⌘ **23.012 CR 015** ⌘ rev **3** ⌘ Current version: **5.2.0** ⌘

Title:	⌘ Addition of ADD feature		
Source:	⌘ Ericsson L.M., Siemens, Telefonica, T-mobile		
Work item code:	⌘ TEI6	Date:	⌘ 10/03/2004
Category:	⌘ B	Release:	⌘ Rel-6
	Use <u>one</u> of the following categories:		Use <u>one</u> of the following releases:
	F (correction)	2	(GSM Phase 2)
	A (corresponds to a correction in an earlier release)	R96	(Release 1996)
	B (addition of feature),	R97	(Release 1997)
	C (functional modification of feature)	R98	(Release 1998)
	D (editorial modification)	R99	(Release 1999)
	Detailed explanations of the above categories can be found in 3GPP TR 21.900 .		Rel-4 (Release 4)
			Rel-5 (Release 5)
			Rel-6 (Release 6)

Figure 4.1.2.1 (sheet 1 of 3): Process Update_Location_Area_VLR

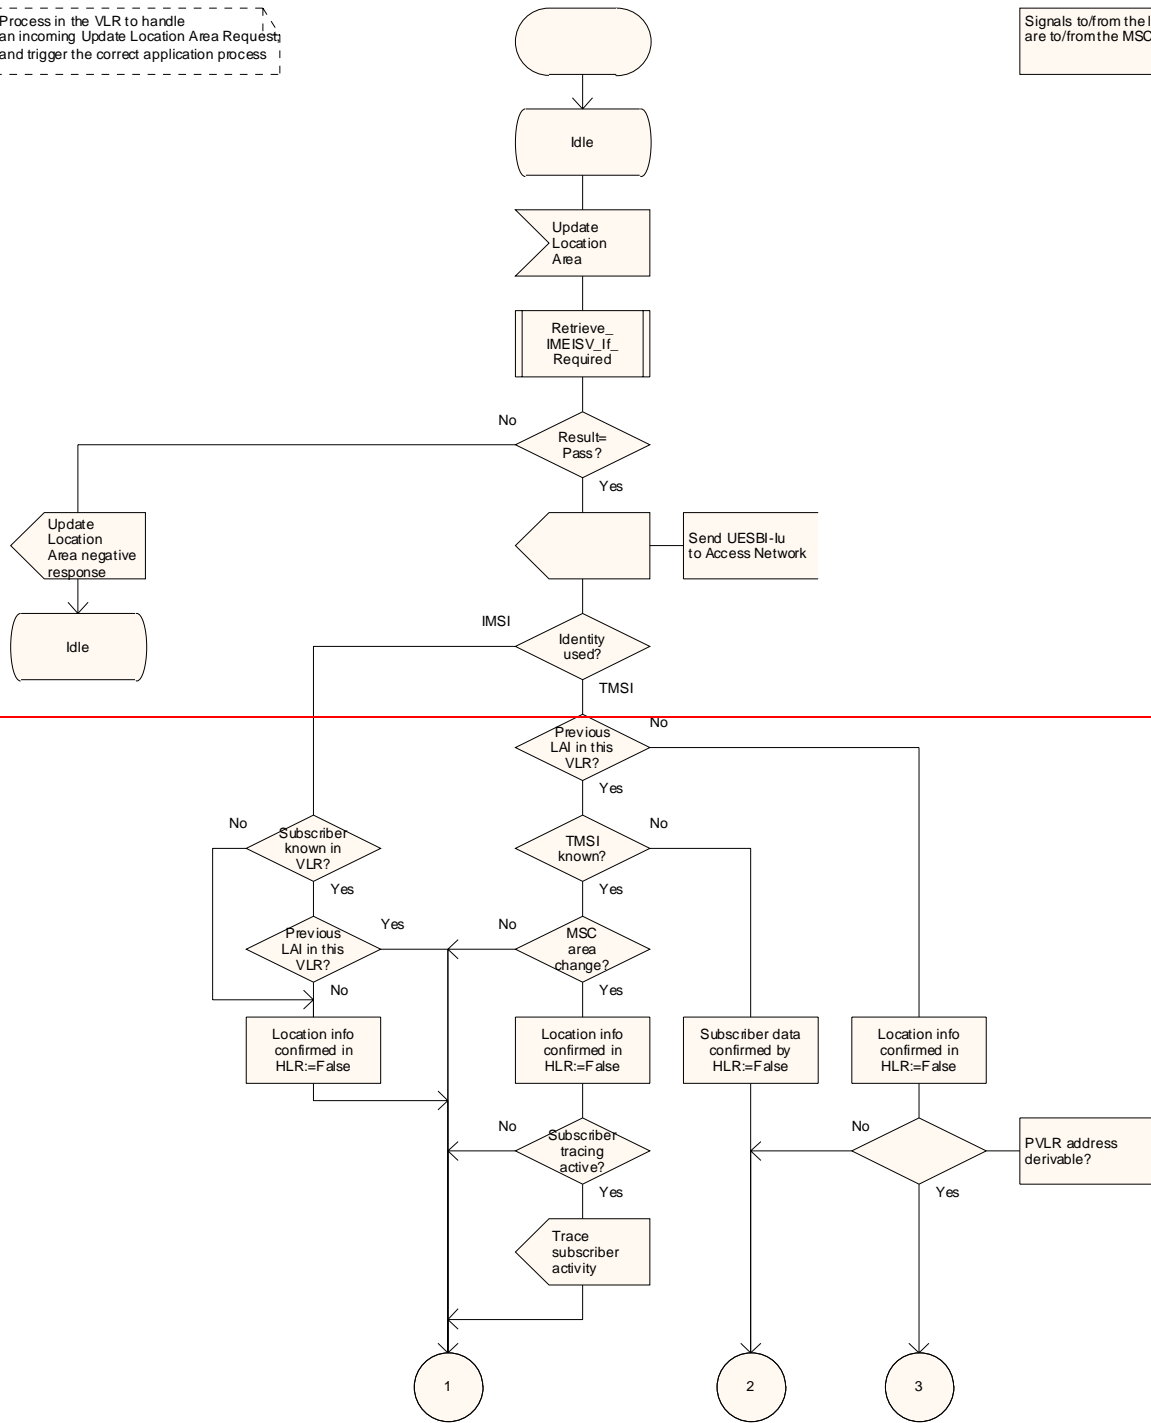
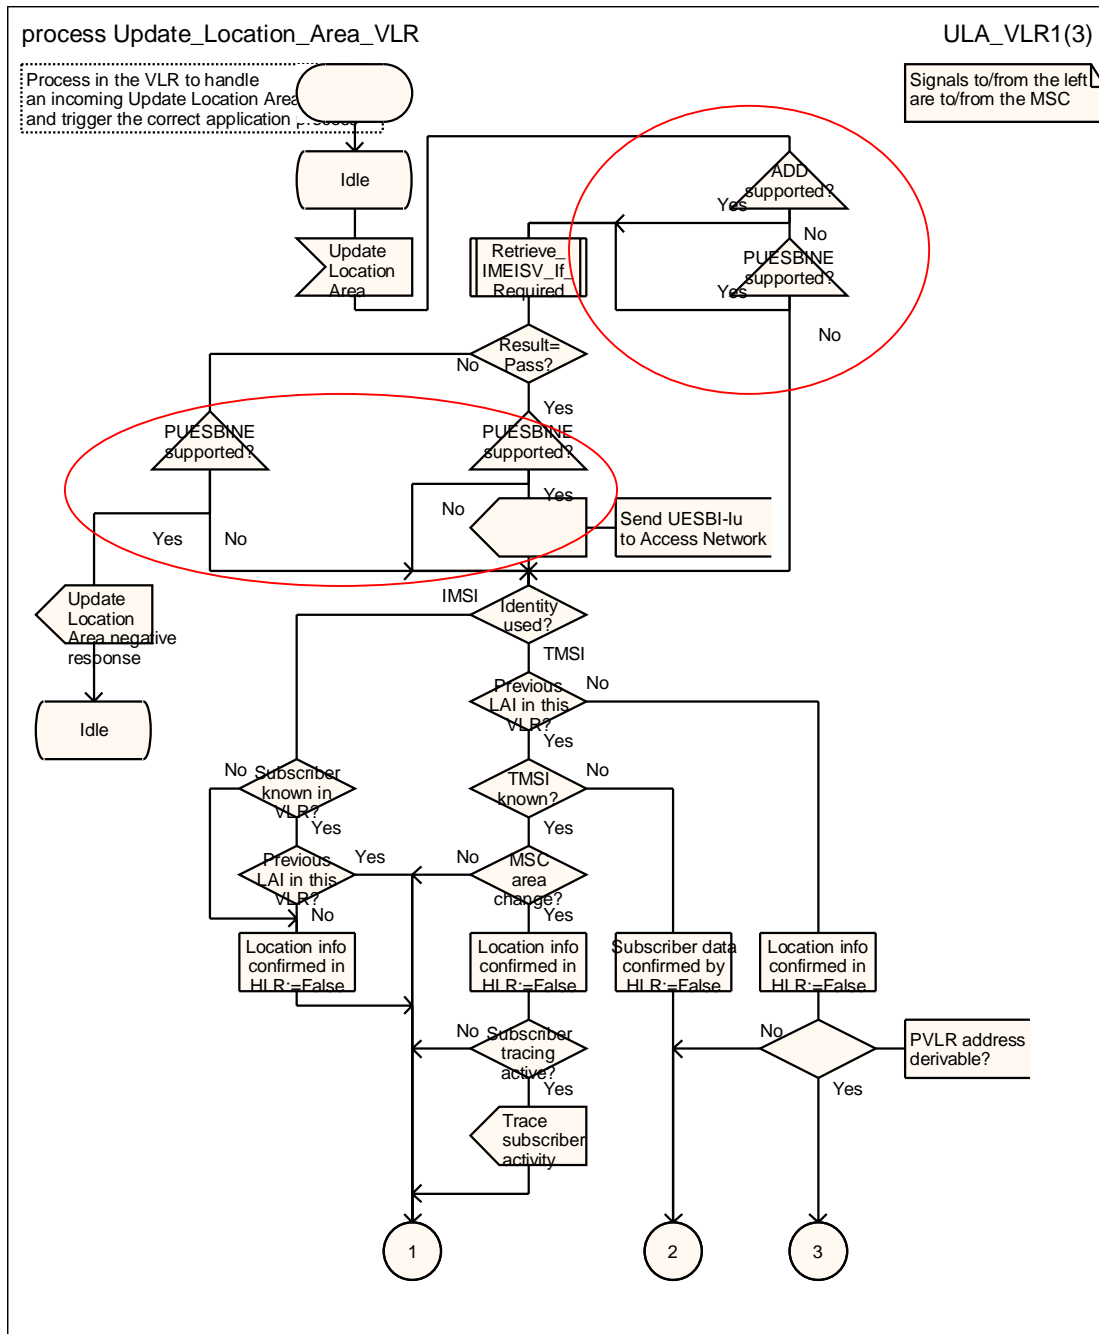
Sheet 1: the location area updating process will be activated by receiving an Update Location Area indication from the MSC. If there are parameter errors in the indication, the process is terminated with the appropriate error sent in the Update Location Area response to the MSC. Else, the behaviour will depend on the subscriber identity received, either an IMSI or a TMSI.

~~Sheet 1: the handling starting with the procedure call "Retrieve_IMEISV_If_required" and finishing with the output signal "Send_UESBI-Iu to Access Network" is specific to PUESBINE. If the VLR does not support PUESBINE, processing continues with the test "Identity used?".~~

The ADD function is an optional feature that allows the HLR to be updated with the current User Equipment (IMEISV) and thus enables the network to configure the subscriber's equipment based on a predefined profile. A device management system can retrieve the IMEISV either from VLR or from HLR, or be triggered by a changed IMEISV in either VLR or HLR. The mechanism for the configuration is outside the scope of this specification. The VLR requests the IMEISV and checks if the stored value is identical to the current one provided at the IMSI Attach/Location Update. If the IMEISV is not the same an Update Location message on MAP to the HLR is triggered including the IMEISV.

Figure 4.1.2.1 (sheet 2 of 3): Process Update_Location_Area_VLR

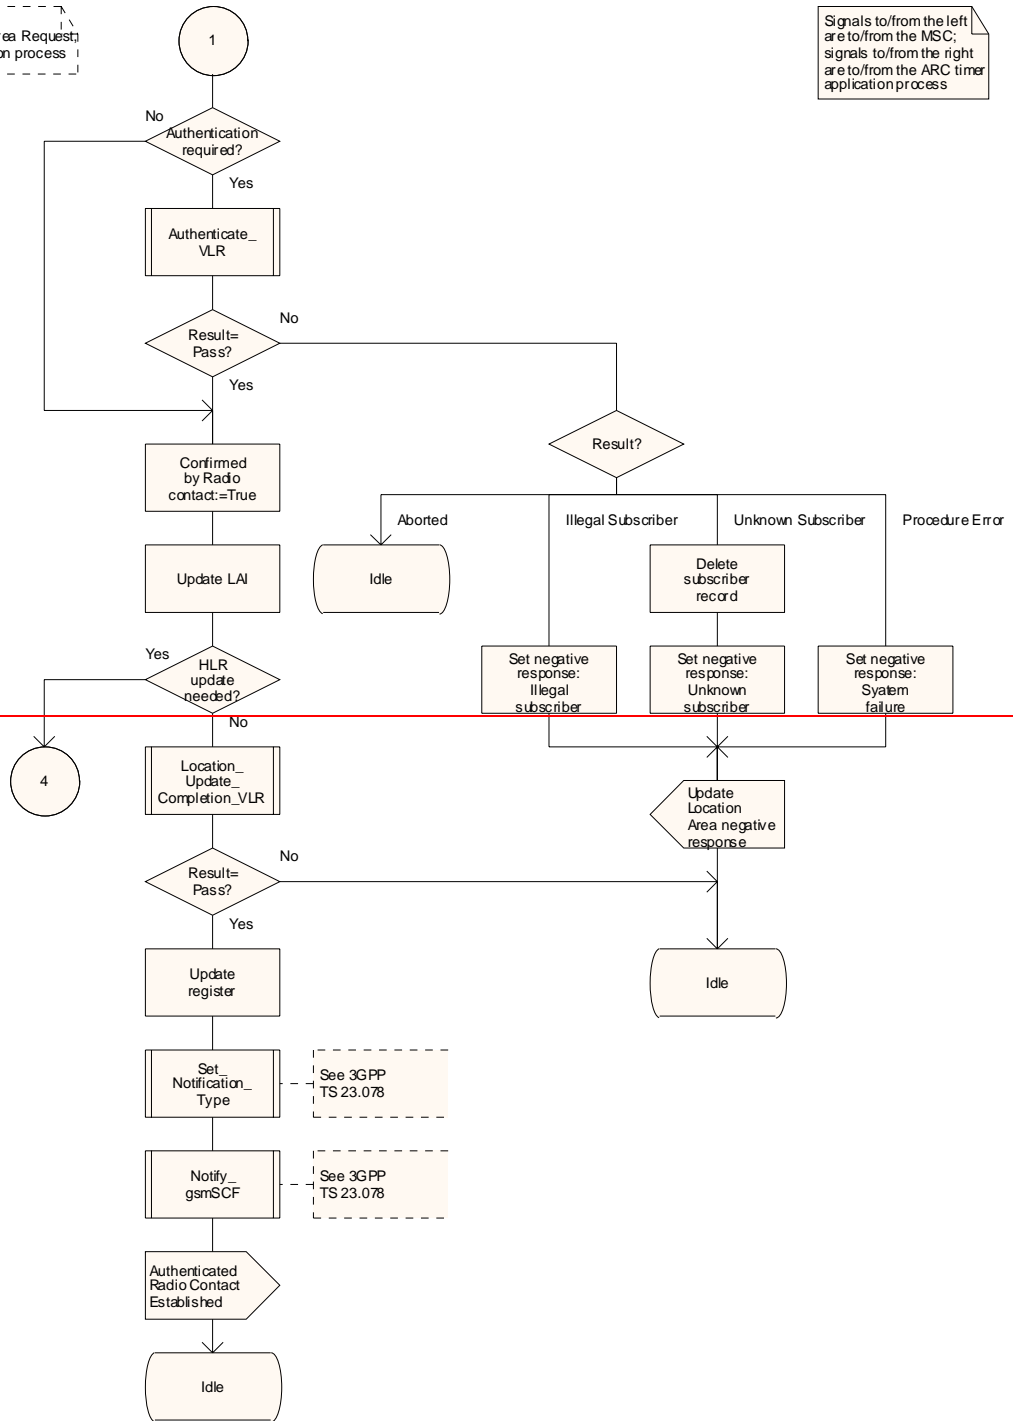
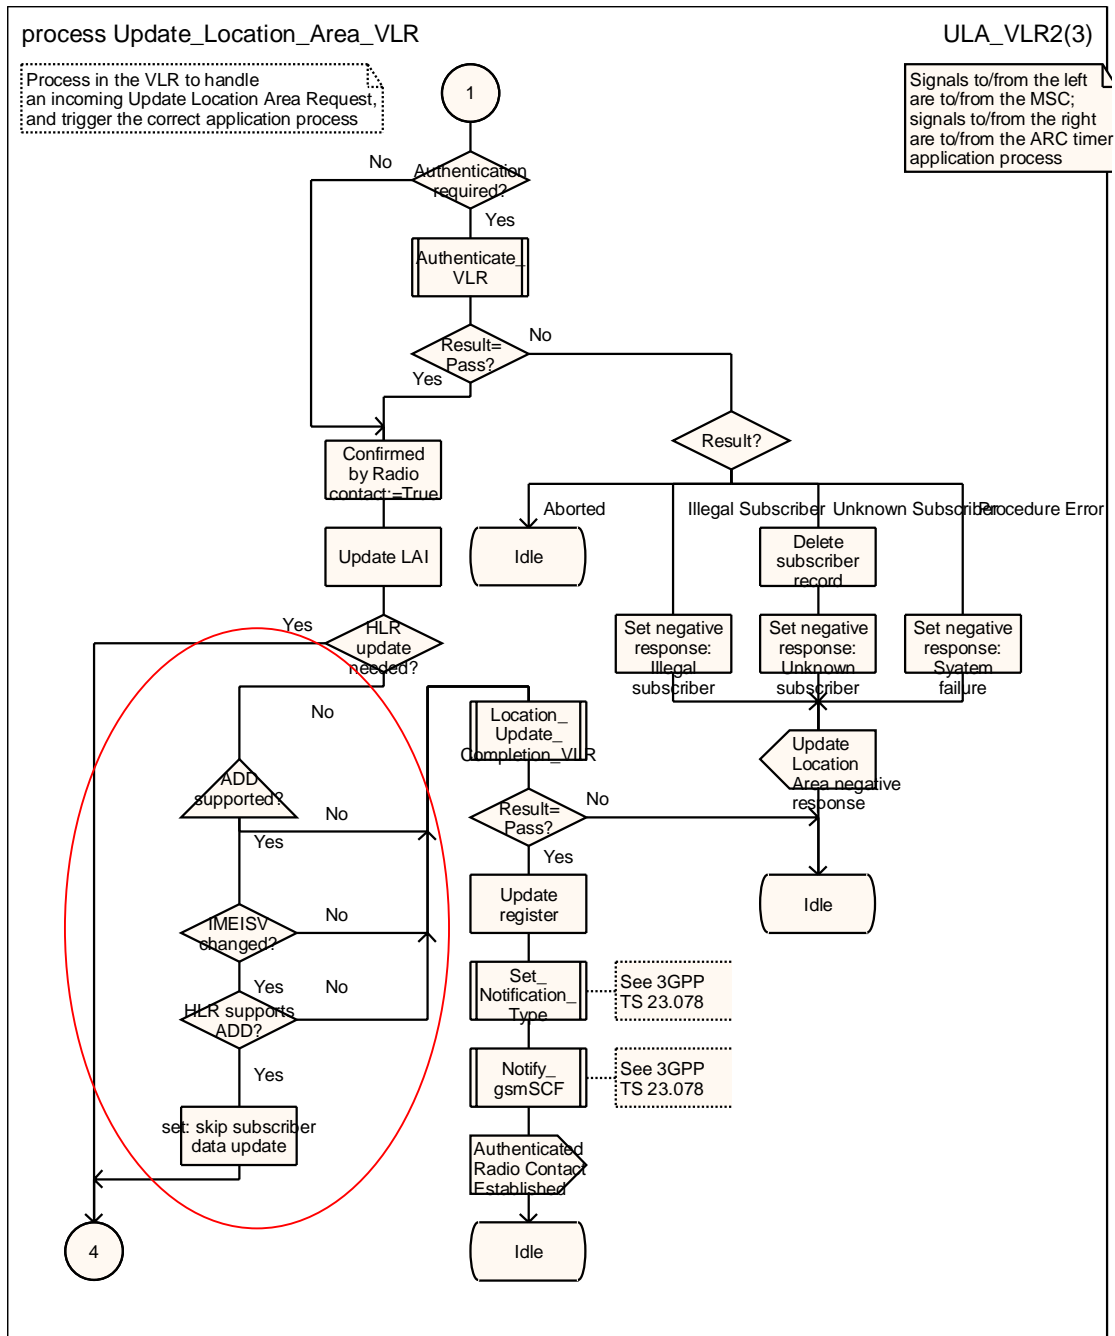
Sheet 2: at the decision "HLR updating required?" the "True" branch shall be taken if and only if one or more of the following conditions is true:

- (1) Location Info Confirmed in HLR is false.
- (2) Data Confirmed by HLR is false.

Sheet 2: : The execution of the test "HLR supports ADD?" and the action "set: skip subscriber data update" is optional and depends on the presence of the relevant indication from the HLR that ADD function is supported. If no indication is received, both are bypassed in which case processing continues at connector 4.

Figure 4.1.2.1A: Procedure Retrieve_IMEISV_If_Required

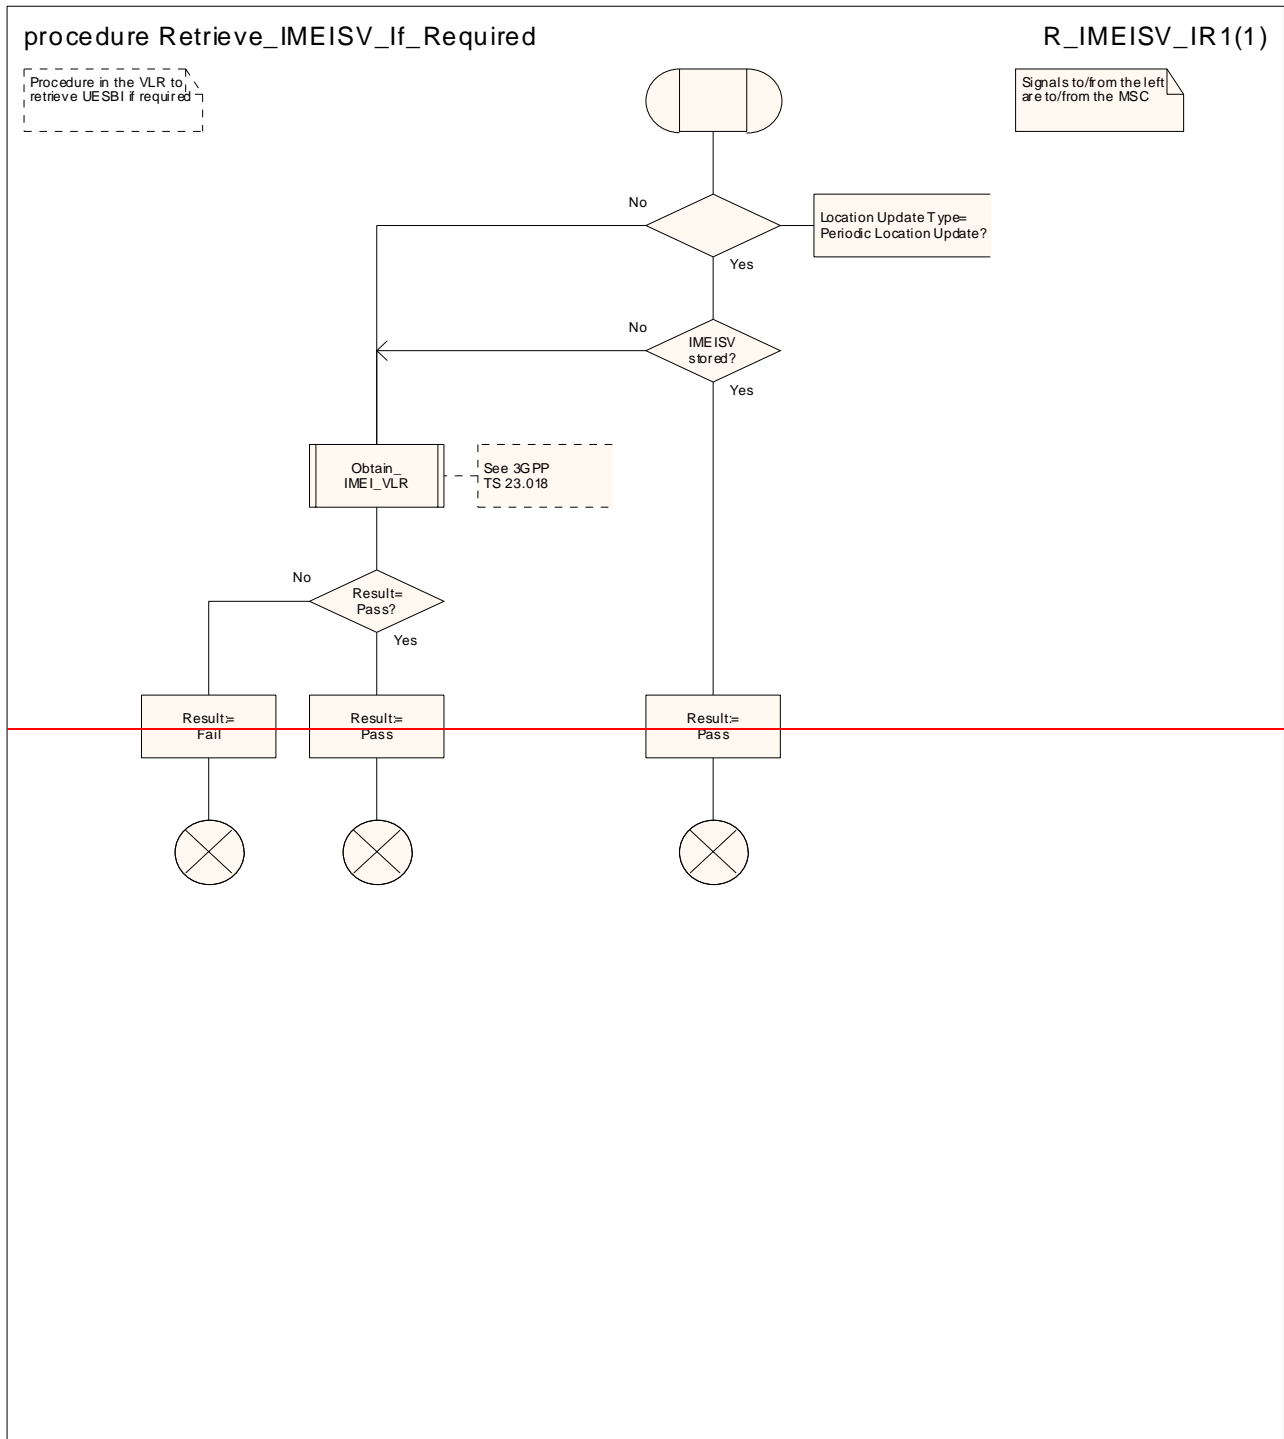
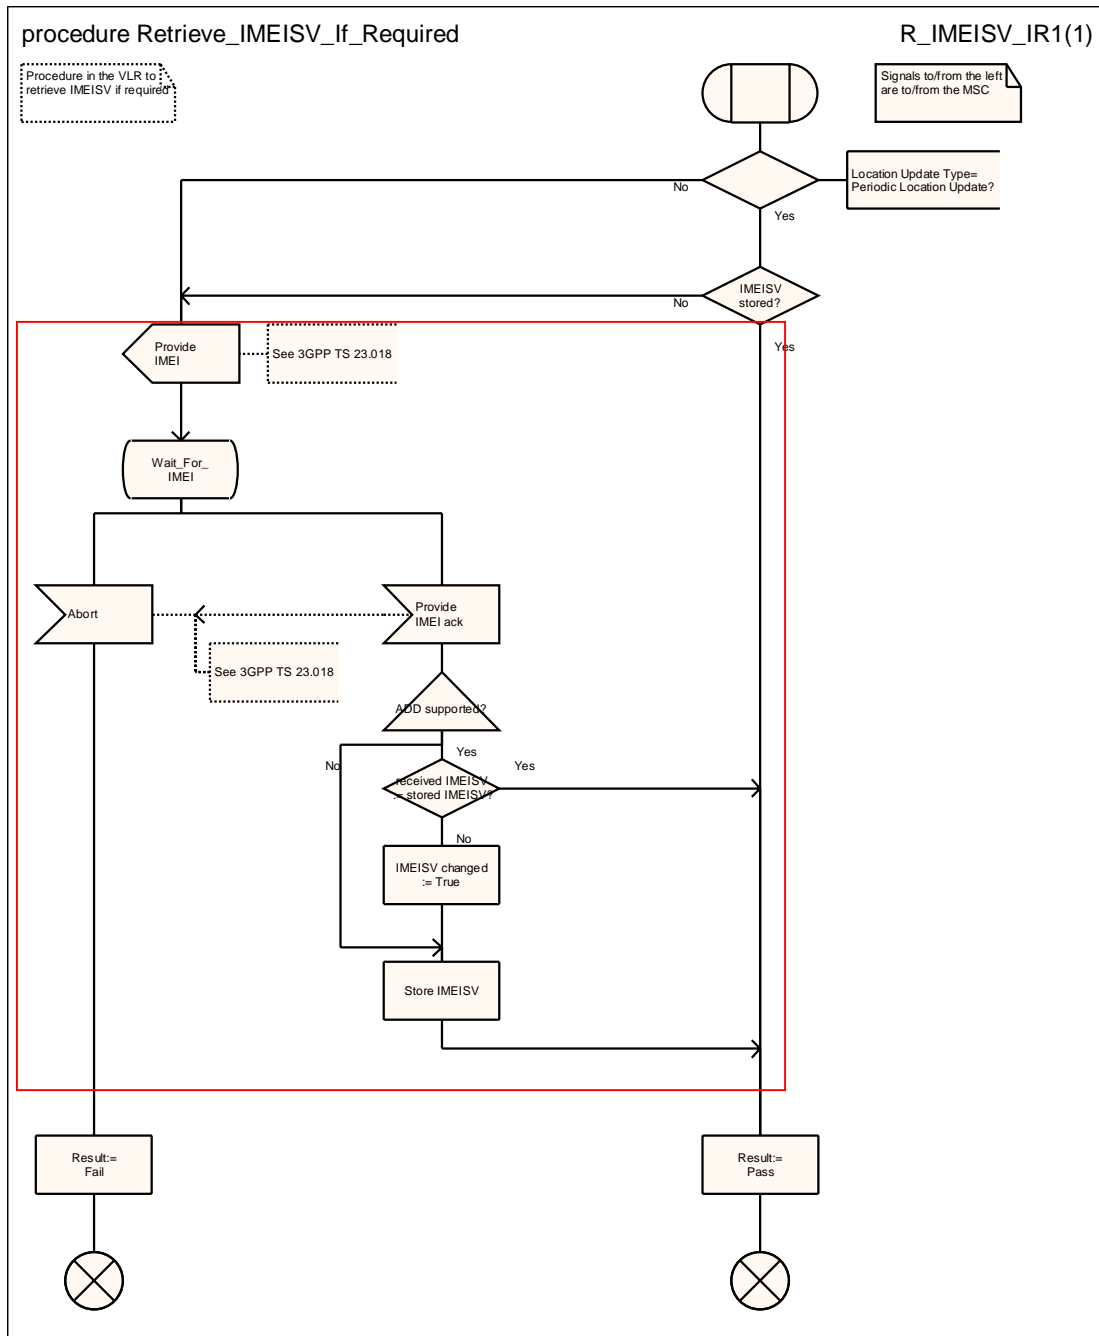
The procedure Obtain_IMEI_VLR is specified in 3GPP TS 23.018 [5a].

The decision box "received IMEISV = stored IMEISV" takes the "No" exit if no IMEISV is stored.
